From: David Leifheit <davidl@nwcodepros.com>
Sent: Wednesday, October 26, 2022 3:28 PM
To: Clare Kurth
Cc: Dave Mortier; Cailin Tang
Subject: Mezzanine or second floor.
Attachments: Overlay.pdf

HOLMAN / SMITH MIXED USE

SCHEMATIC DESIGN
08/16/22

BUILDING PLAN - LOFT
1" = 10'-0"

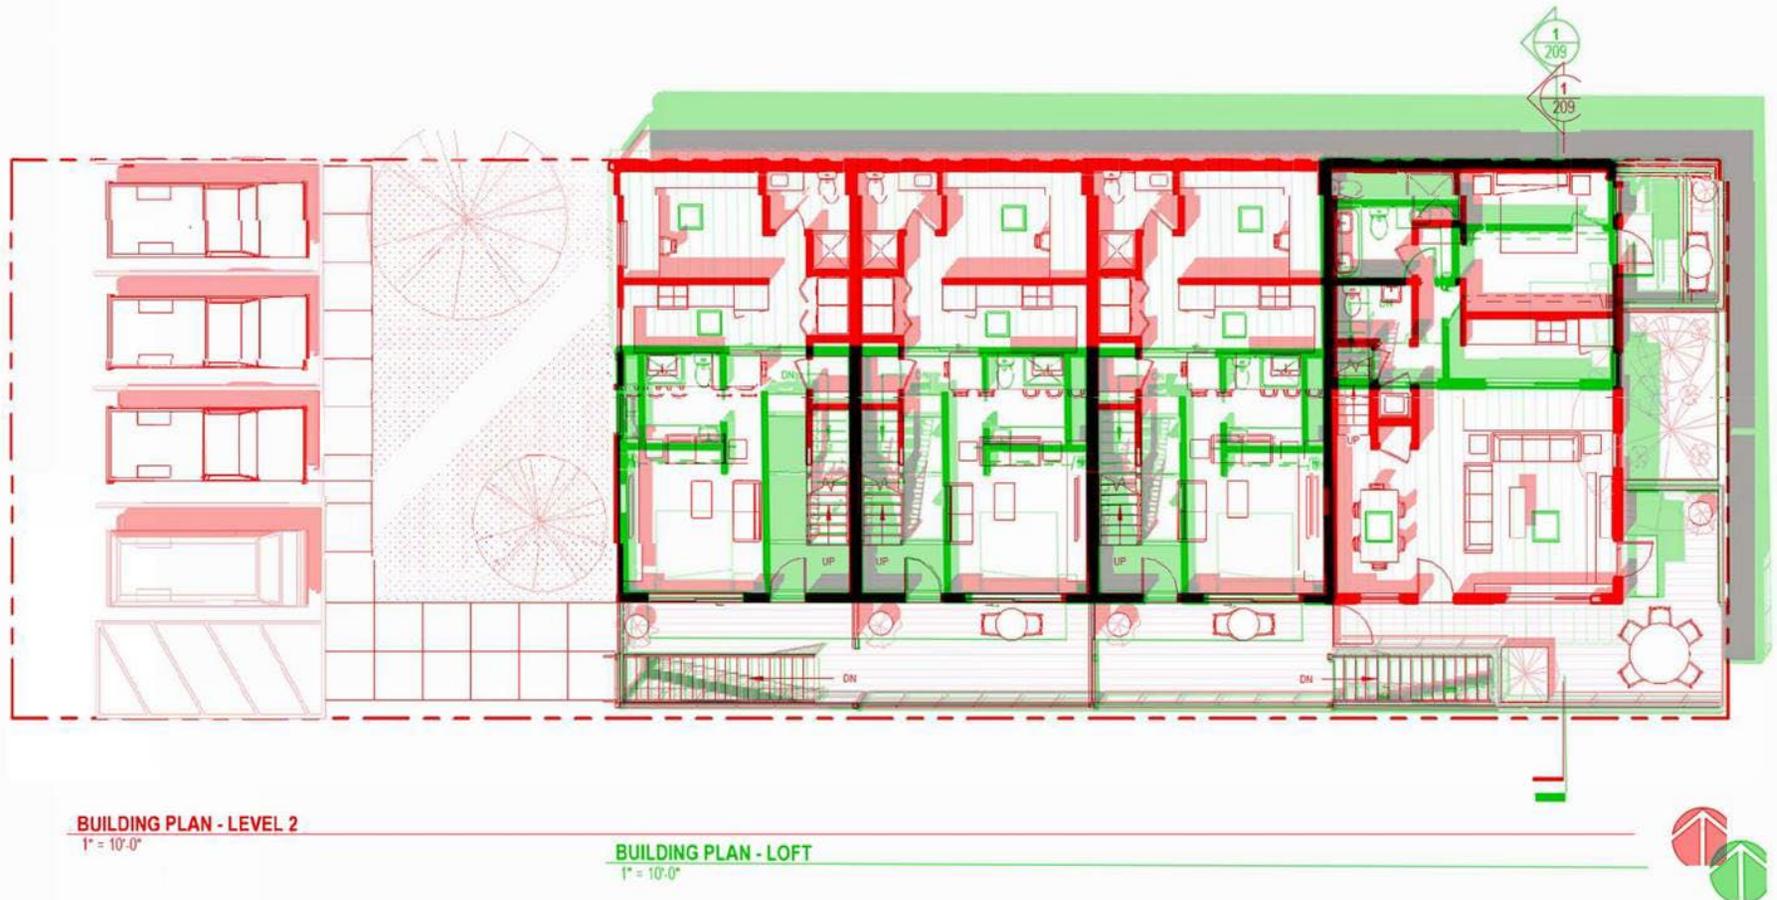
Second. When I overlay the third floor over the second floor, it appears that the third floor, the “mezzanine” is at least half if not more of the floor below.

Taking their numbers, 2nd floor one bedroom 720 sf and subtracting the bathroom, pantry, and laundry, the given 240 sf “mezzanine” is over 1/3 and would per 505.2.1 exc. 3 be required to be fully open to below.

The same is true of taking the 2nd floor two bedroom, deducting the enclosed areas of 2 bathrooms, laundry, and a bedroom, the 288 sq ft mezzanine” would be well over 1/3 and also would be, at best, required to be fully open to below.

Looking at the overlay, it does not appear to be less than 1/3, and it really does not appear to be less than half of the floor below.

The only one that is close to half is the larger unit, from what I can tell.

Note that the Green is the third floor, the red is the second floor.

In my opinion, just from looking at the two floors in relation to each other, these are floors.
Further, when estimating the areas, the 3rd floor does not meet the definition of a mezzanine per 505.2.1 exc. 3

So this is a 3 story building.
